ZONING BOARD OF APPEALS APPLICATION

Project Street Address: 309 Pondfield Road, Bronxville NY 10768

ZONING REVIEW COMMENTS

APPLICATION NUMB: ALT 226-21
DATE RECEIVED: November 23, 2021
LOCATION: 309 Pondfield Road
SBL: 8./4/5
APPLICANT NAME: Nordic Custom Builders, Inc.
APPLICANT ADDRESS: 525 East Putnam Avenue
Cos Cob, CT 06807

6 CARRIAGE HOUSE - EAST ELEVATION
1/4"=1'-0"

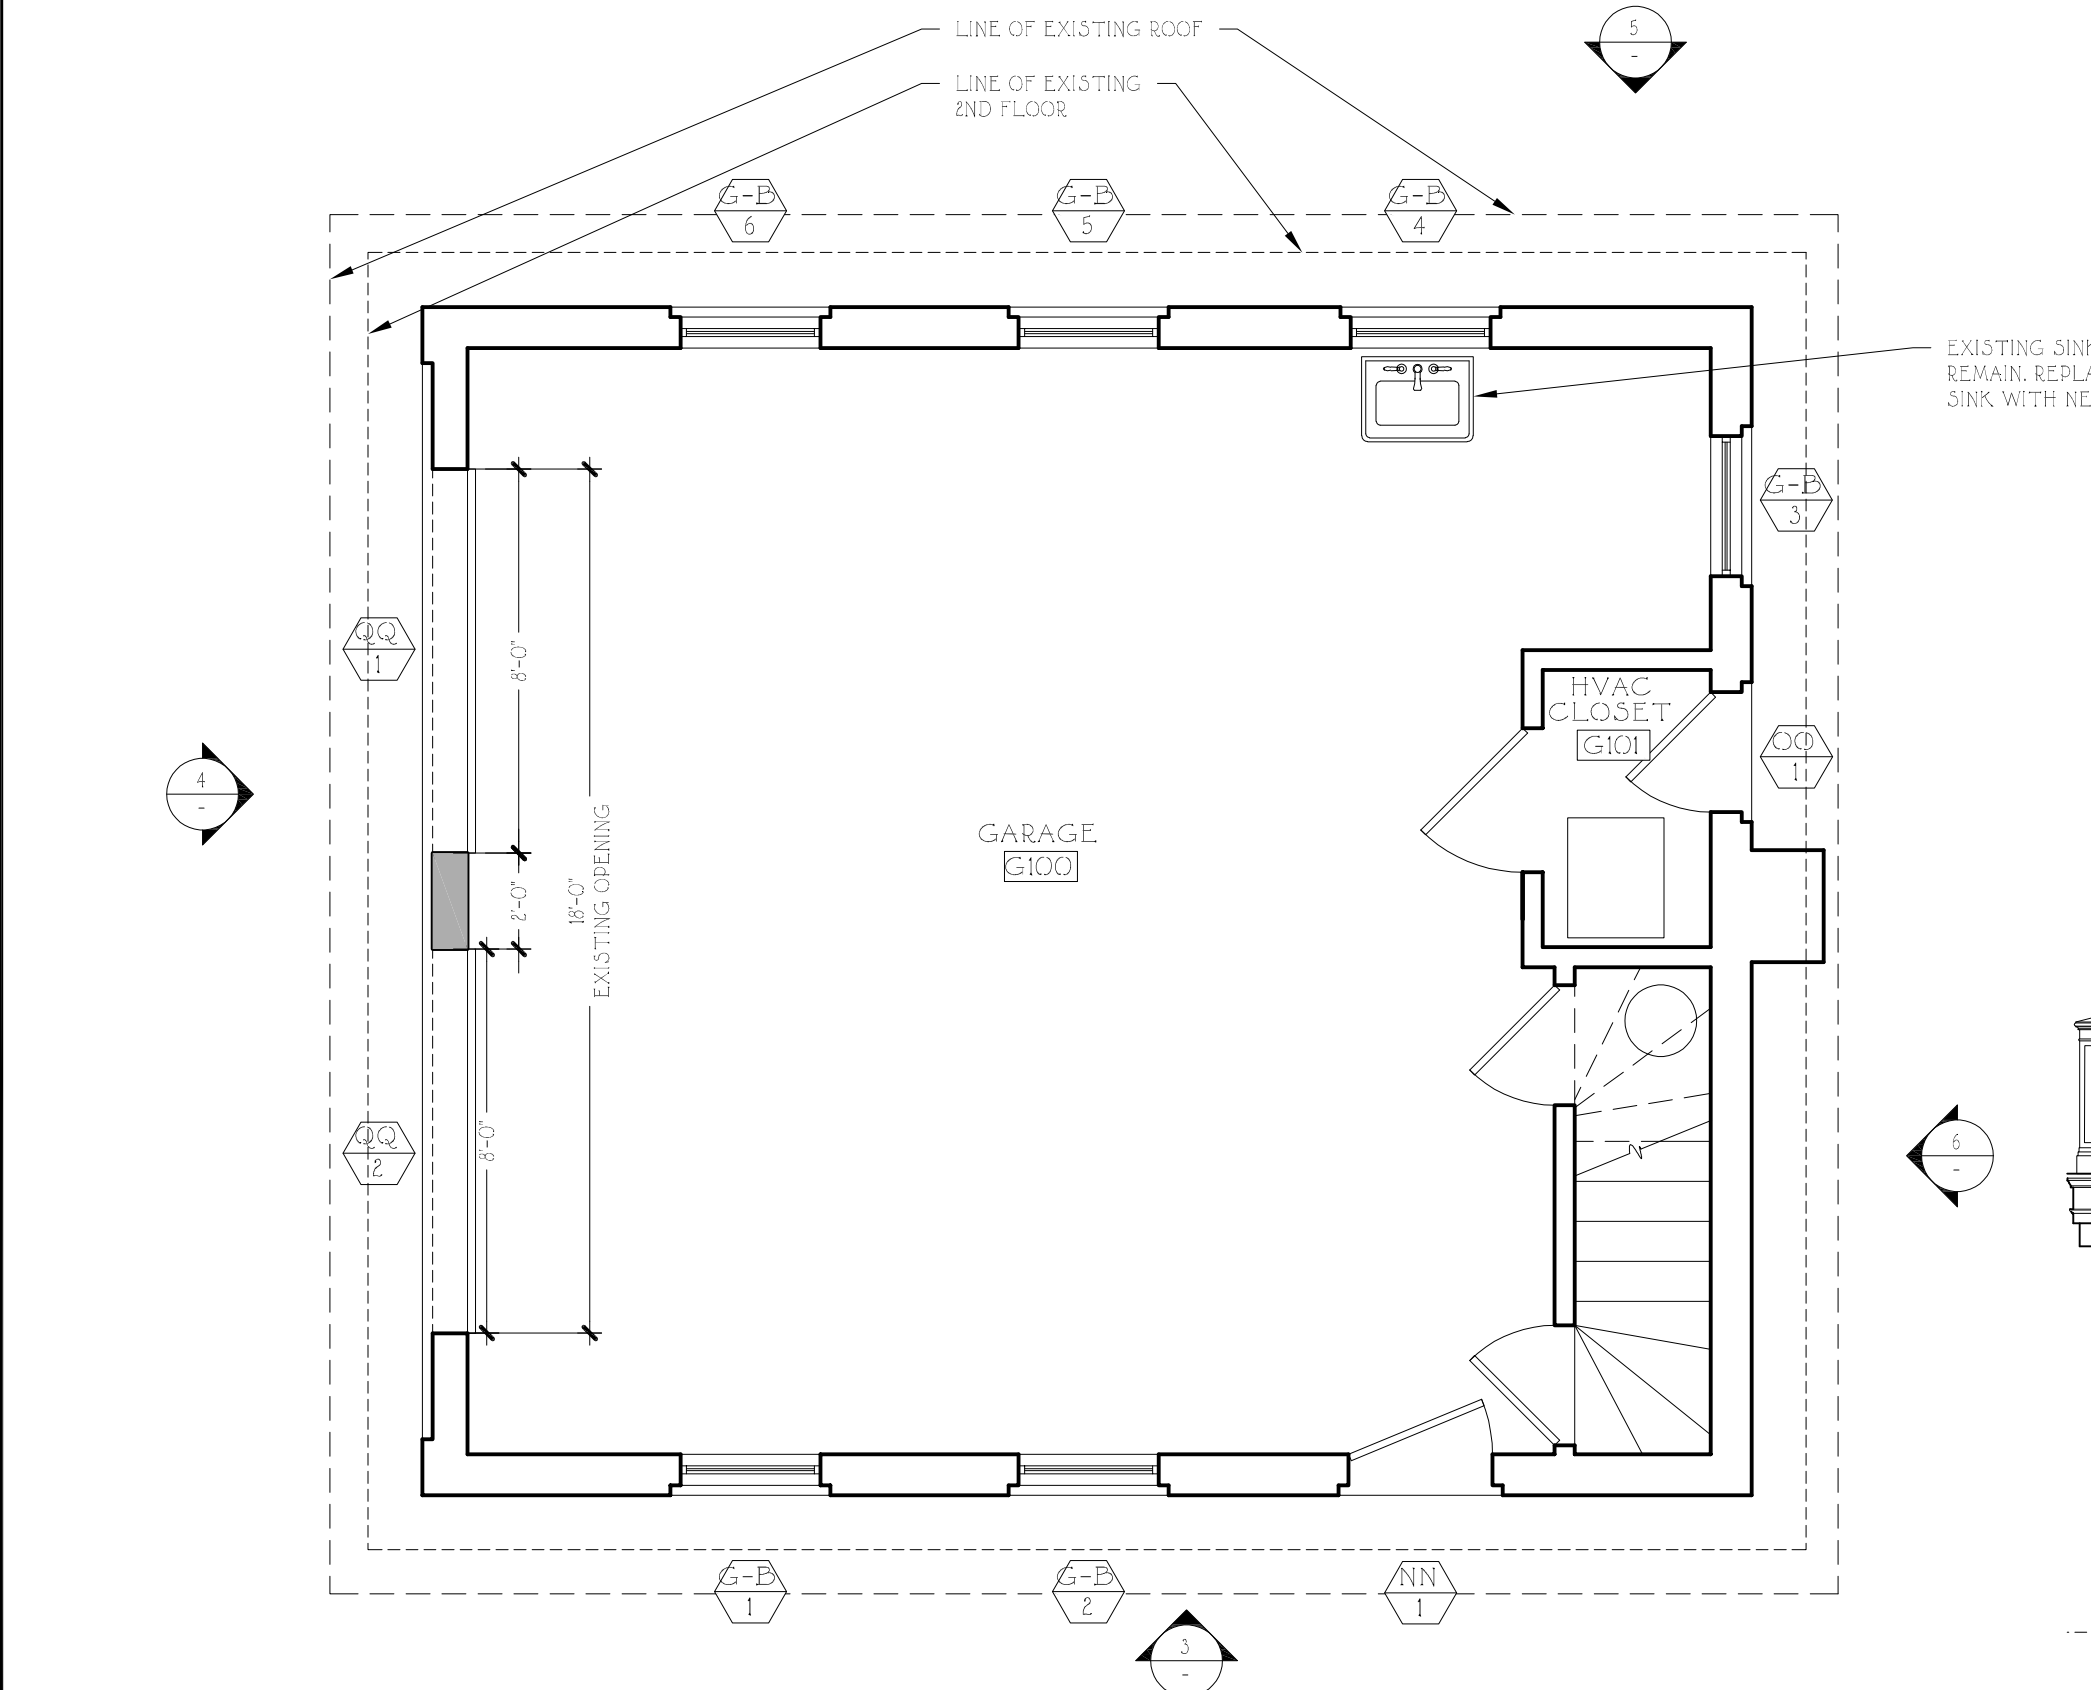
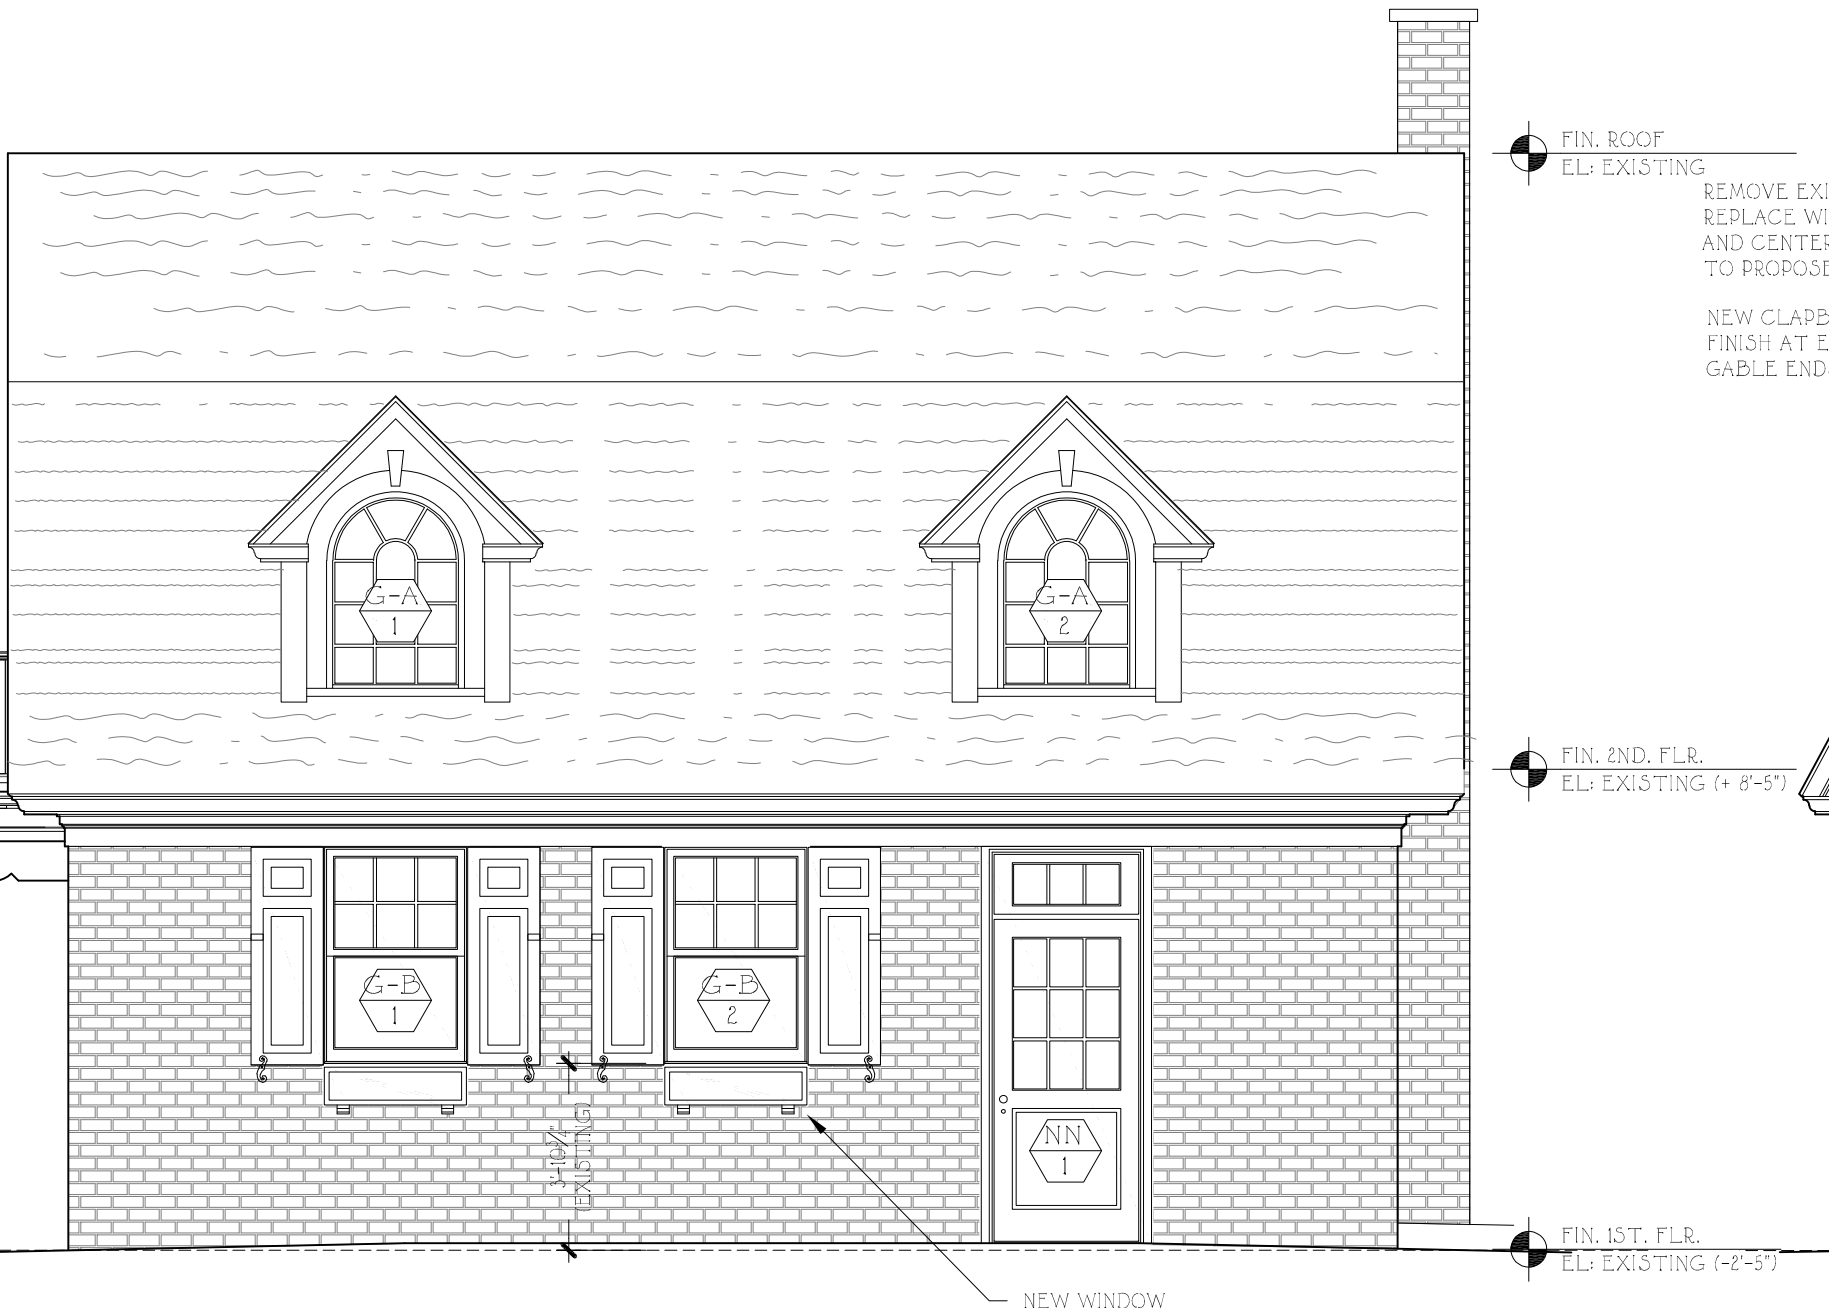
1) Extension of 2nd floor of Garage (Balcony) is an increase in non conformity of the side yard setback (4'-2"). The side yard setback of 4'-2" for the garage is a pre-existing non conformity.

2) Referral to Village of Bronxville Zoning Board of Appeals for an increase on non-conformity inside yard setback - corner lot as per
